**Notice of request for more information**

Environmental Permitting (England and  
Wales) Regulations 2016

**Application number: PAN-0065814**

Natural Resources Wales, in exercise of its powers under paragraph 4 of Part 1 of Schedule 5 of the above Regulations, requires you to provide the information detailed in the attached schedule. The information is required in order to determine your application for a permit, dated **29/08/19**.

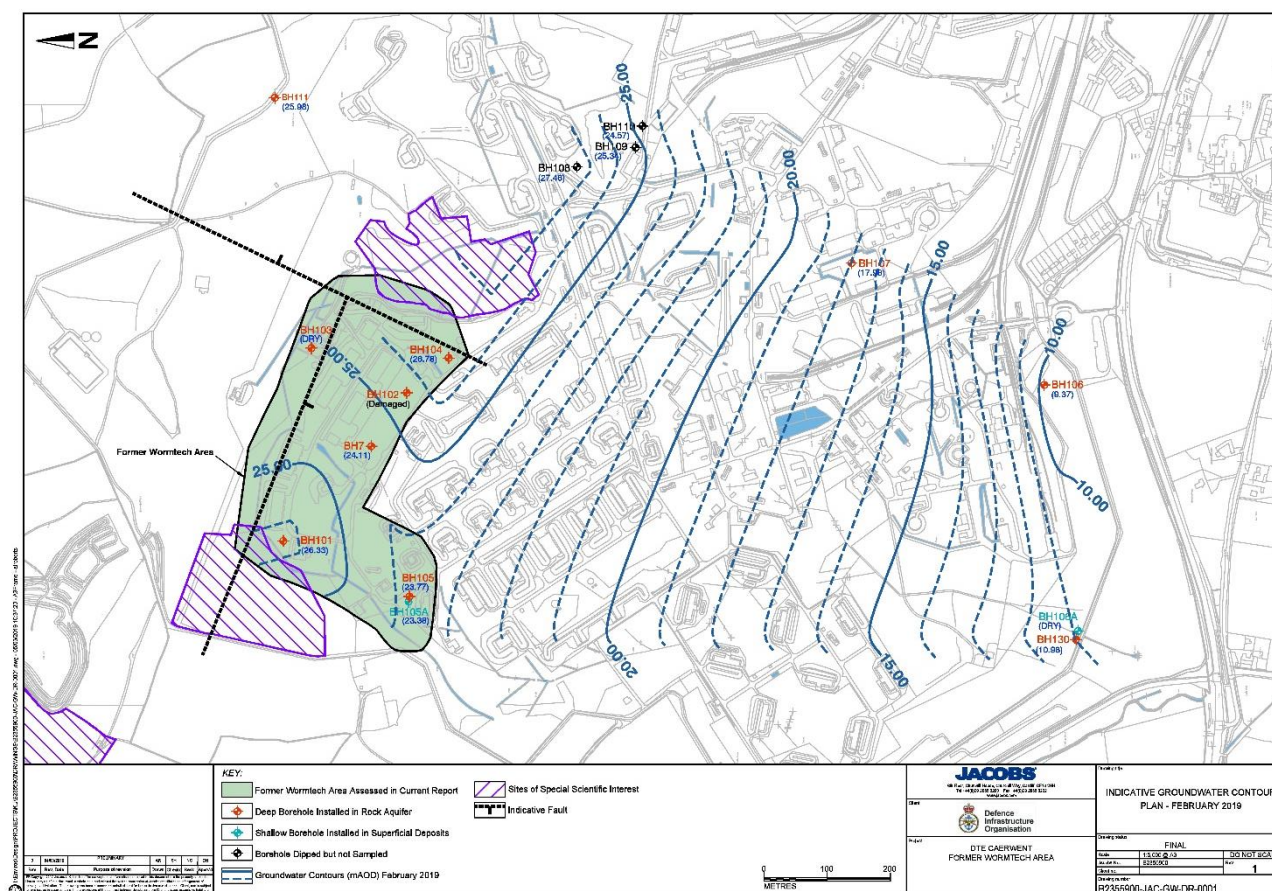
We require details on the groundwater compliance points to include a map showing the locations of the boreholes and the geological and construction logs, details on the frequency of monitoring and determinants to be sampled for and the assessment criteria values (compliance limits) stated. We also require a contingency plan to be submitted that outlines what action will be taken should the compliance limits be exceeded.

- Please amend the location of the off-site compliance/monitoring point to one which is closer to the site boundary and is within the same groundwater catchment area – Due to the layout of boreholes at the site – [Please see below](#).

- Please amend the location of the surface water compliance/monitoring point to one that is closer to the site boundary – [Please see below](#).
- Please provide a map showing the locations of the boreholes and the geological and construction logs, details on the frequency of monitoring and determinants to be sampled for and the assessment criteria values (compliance limits) stated and a contingency plan should the limits be exceeded – [Map illustrating locations of boreholes attached](#). We do not have geological and construction logs for these boreholes. The MoD have agreed to replace / repair the five damaged boreholes and we will request geological and construction logs for these. Monitoring of surface and groundwater at the site is complicated by the historic contamination from the Wormtech operations and the remainder of the green waste which was left on site following this. Jacobs have recommended quarterly monitoring of surface water and biannual groundwater monitoring of the locations

monitored during their 2016 screening visit.

Crownhill establish surface water compliance points on the drainage ditch at the SW corner of the site (CHSW001) and at the discharge point into the Castrogi Brook (CHSW002). Monitoring will be undertaken at monthly at these compliance points (except for periods when there is not flow), for suspended solids, BOD ATU, electrical conductivity, TPH (speciated), and ammonia.
